RECEIPT DATE: 2-24-23 **ONSITE SEWAGE DISPOSAL SYSTEM** P 572799

PROPERTY ADDRESS: 1420 Long Corner Road

**From:** Williams, Jeffrey  
**Sent:** Thursday, March 2, 2023 2:47 PM  
**To:** Frank White  
**Subject:** 1420 Long Corner OSDS plan  
**Attachments:** 1420 long corner markup.pdf; O&M agreement 4.23.18.pdf; [Untitled].pdf

LOT 1, SNIDER PROPERTY  
ON SITE DISPOSAL SYSTEM PLAN  
1420 LONG CORNER ROAD  
MOUNT AIRY, MD 21771  
TAX#: 331303, SUB: 1002

FOUNDATION LOCATION DRAWING  
**1420 LONG CORNER ROAD**  
 TAX MAP 6 GRID 10 PARCEL 25  
 4TH ELECTION DISTRICT      HOWARD COUNTY, MD

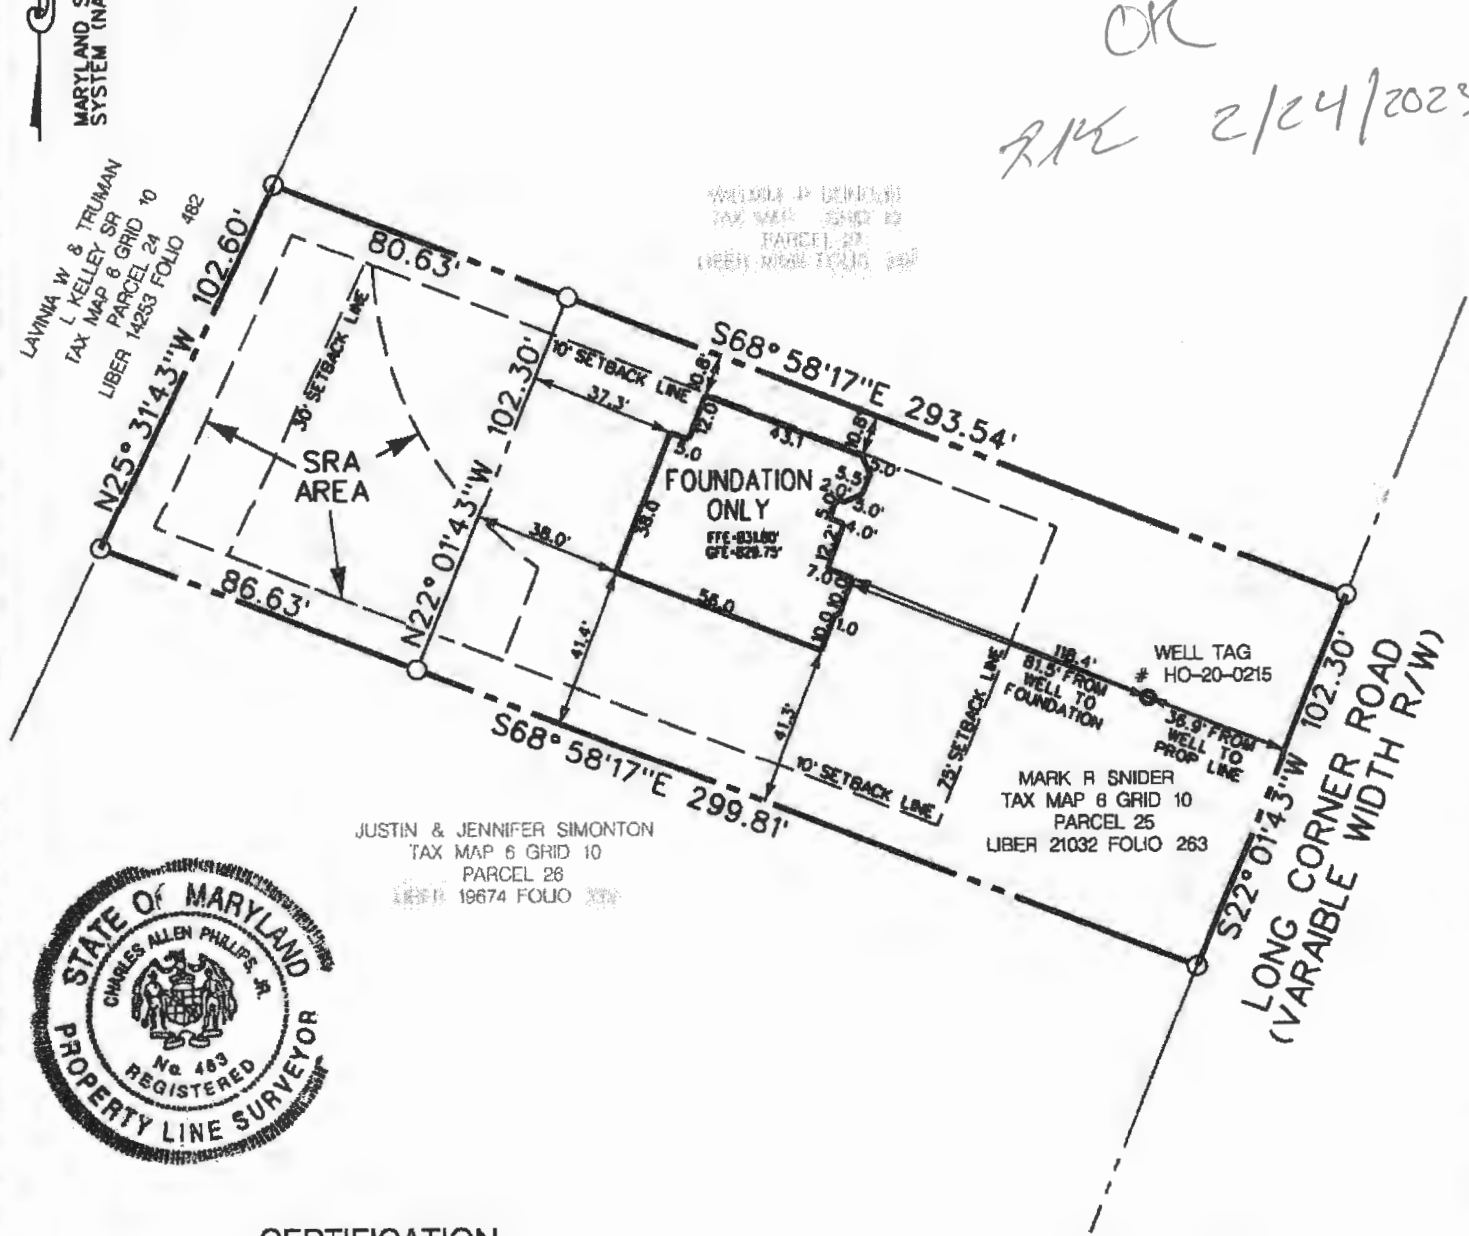
4/10/23 - met contractor onsite, tank stake in place, laid out 3 trenches @ 42' each along contour according to plan. Ok to start install. (OK)

4/11/2023 - Saw c/o from house. 120k set & connected to house. Pipe used is solid 9" d-box set, installer just started trenches. Stone on site loaded. Dis. Got tank specs gave or to backfill from 120k to c/o (OK)

4/12/23 - site inspection - contractor working on final trench (trench A on the plan) during construction the contractor hit an old drywell which was empty - 15' in diameter, consultation w/ HD determined that he could run solid pipe thru the void of the drywell and then pack the bottom w/ dirt to prevent effluent intrusion, drywell observed, ~ 15'/20' of solid pipe used and stone was added to fill in the drywell in that area of the trench. Site restrictions caused this on the fly decision and the trench A end will be extended to make 42', d box level w/ levelers stone not great, appeared not to be washed very well - could use another washing but all stone install prior to inspection, engineer to red

line the plan, geotextile fabric in place (x3 trenches), ok to continue. (OK) 4/15/23 - last trench completed geo-textile fabric in place, stone ok not great observation part installed, drywell located during installation was filled in w/ stone & clean fill and the solid pipe was used through that area, made up the rest of the 42' of trench by extending the trench, ok to back

PLAN VIEW  
SCALE: 1" = 30'

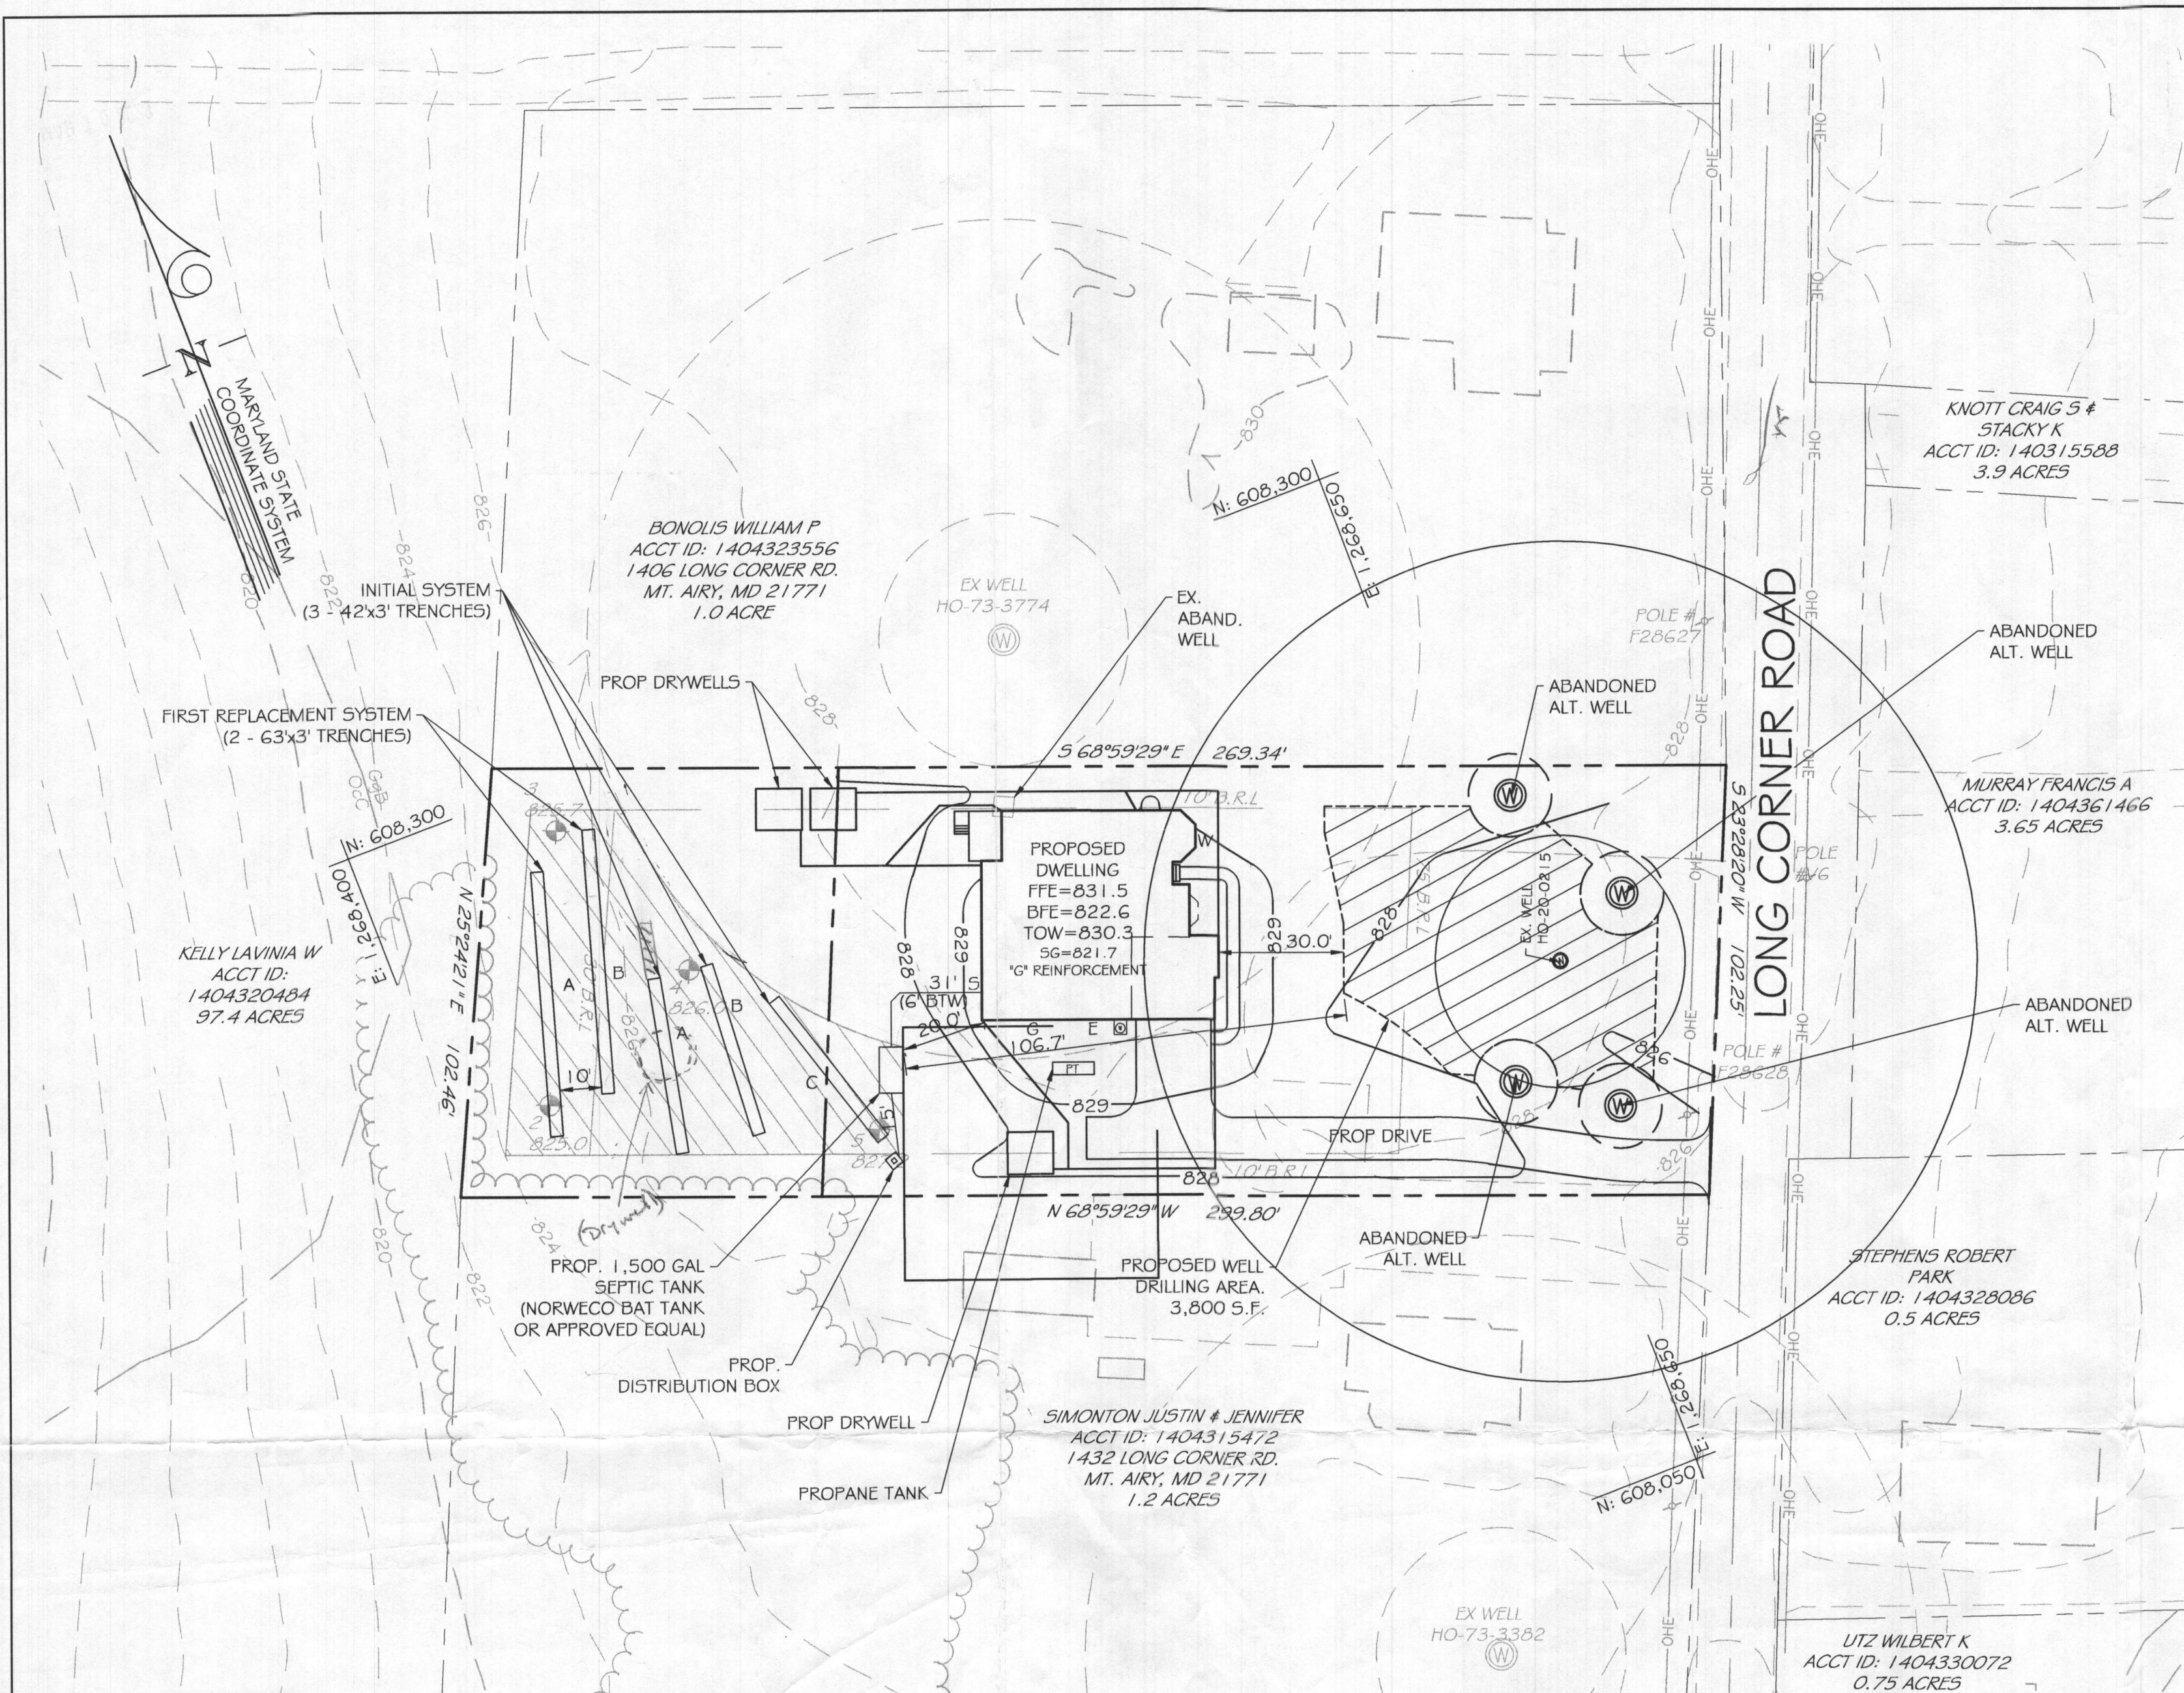
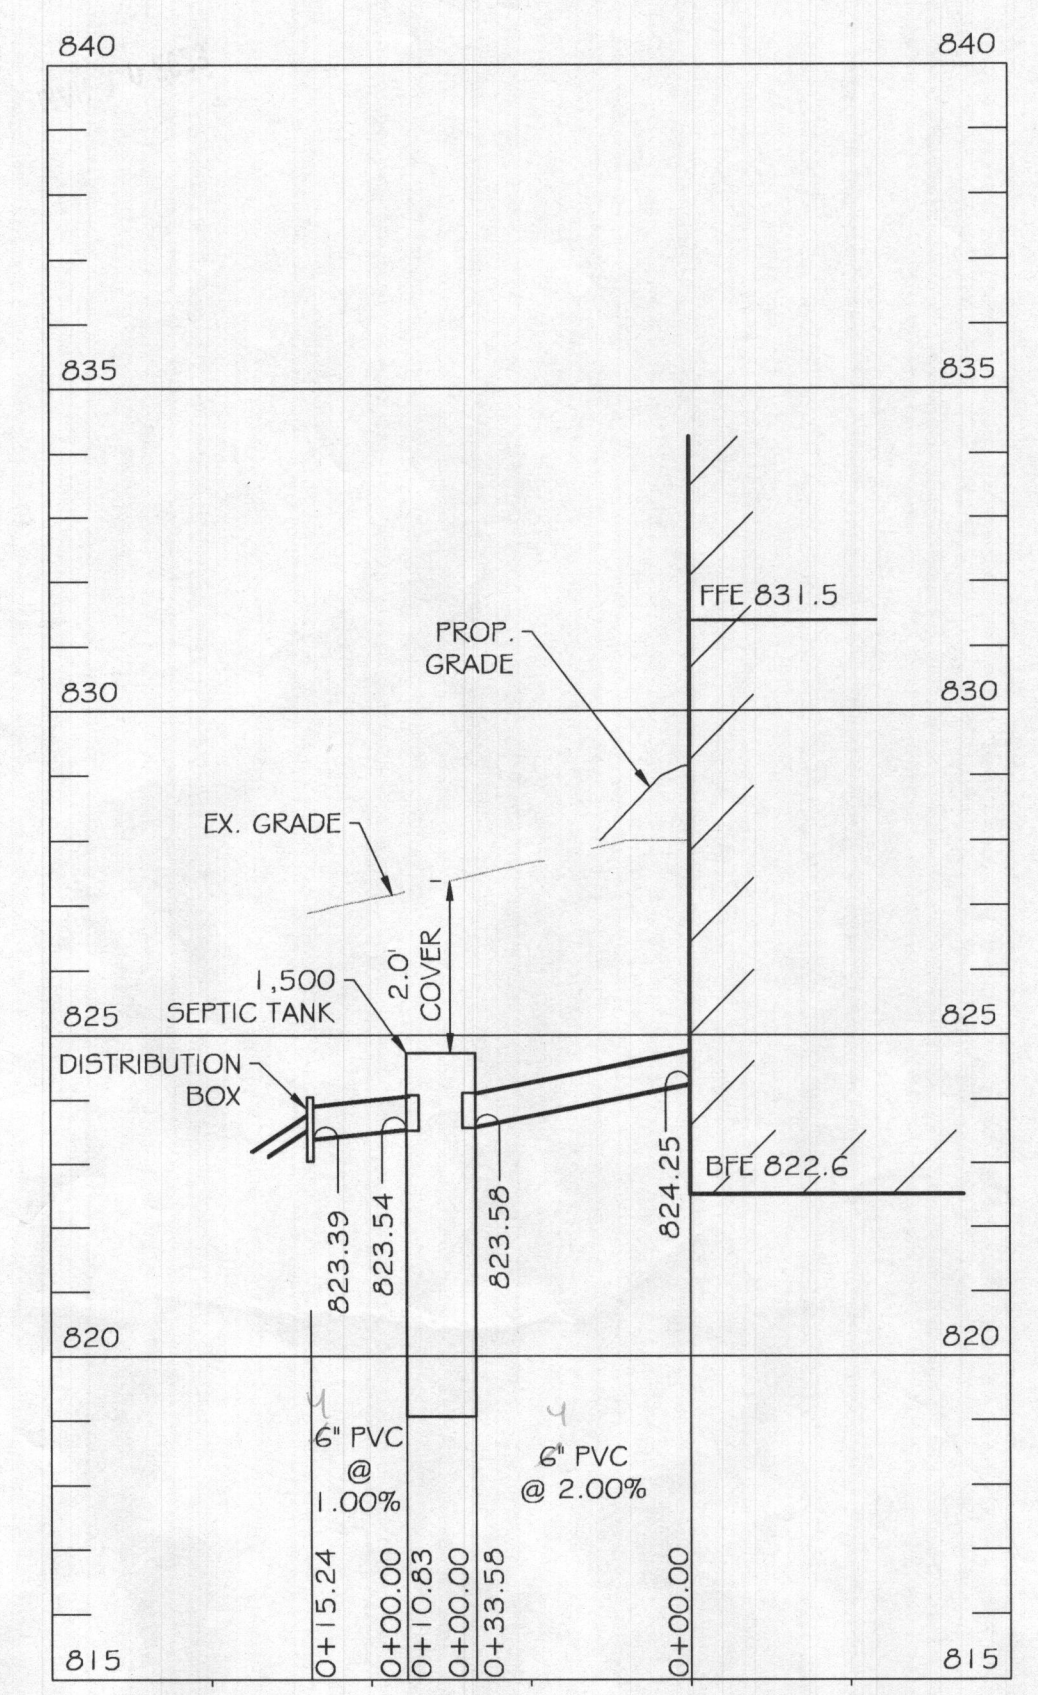
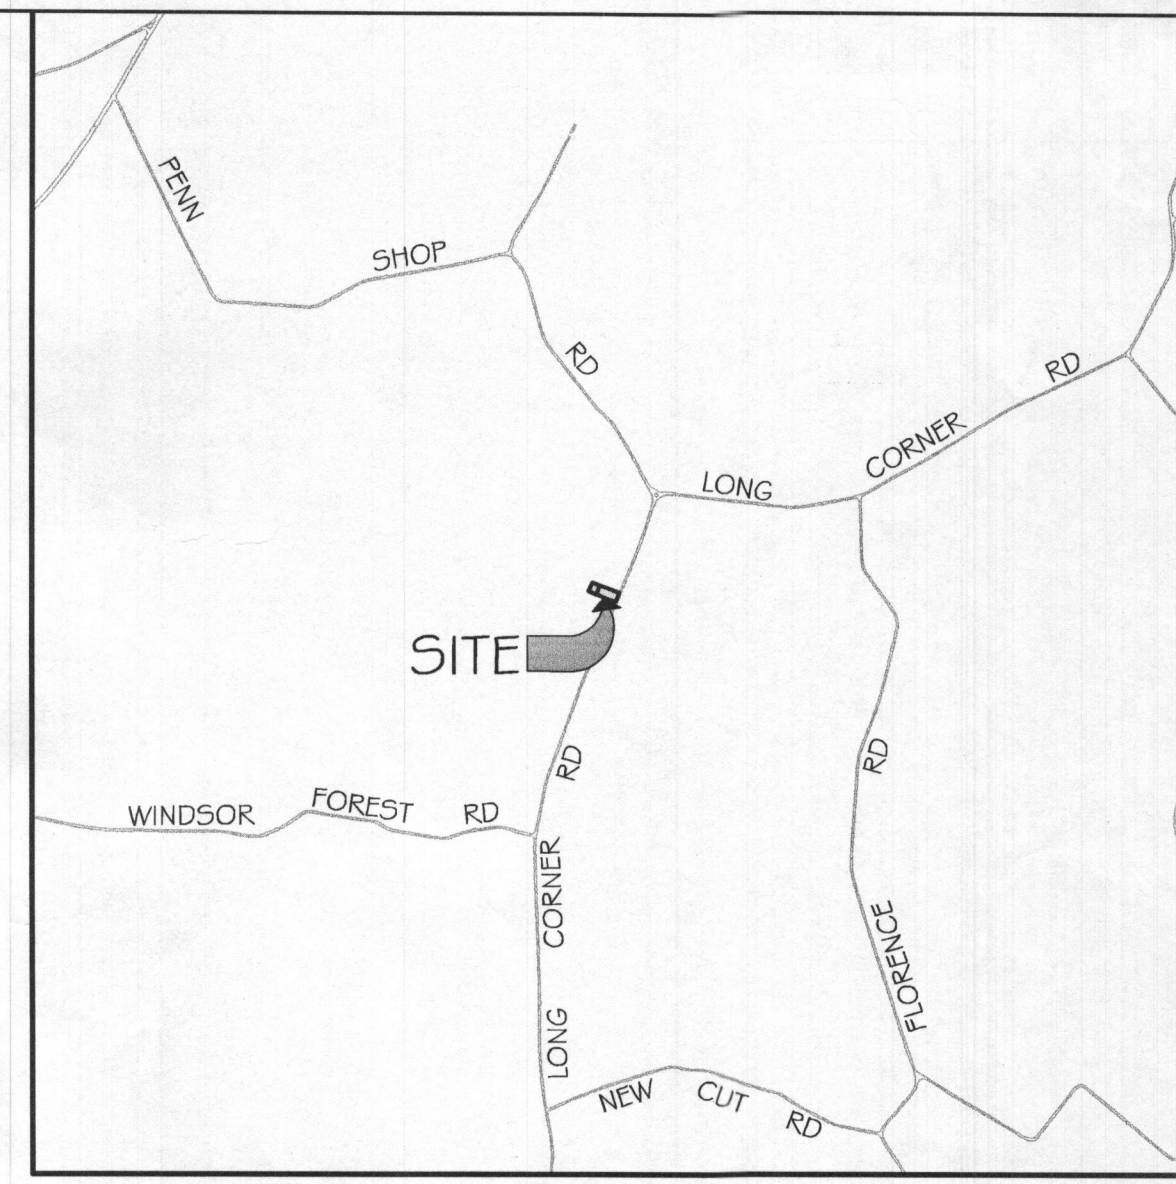
1. The proposed system is utilizing trench depths that deviate from our spec sheet. See the attached spec sheet from 2020. The plan shows trench invert at 7' and bottom at 10'. The max bottom depth here is 7' and we never allow a trench invert below 4'. It looks like you will have fall to move these up.

2. You show only an initial plus one replacement system. Per the spec sheet and our Code, this always requires a BAT unit. You will need to replace the tank on the plan with the model of BAT unit of your choosing. Also see attached O&M agreement. We will need that agreement signed by the owners and us and recorded in Land Records before we can issue a septic permit.

3. The tank location is within the 100' well arc of the neighbor's well. See my markup for a possible alternate location that meets the 100' and the 25' setback to the stormwater drywell. This also shows a suggested d-box location. Your location is on top of one of the trenches, which we don't allow.

4. You show the trenches 9' apart. The minimum separation for trenches using sidewall is 10'. It looks like you can shift the lowest trench down and twist the others a little so the minimum spacing is 10'
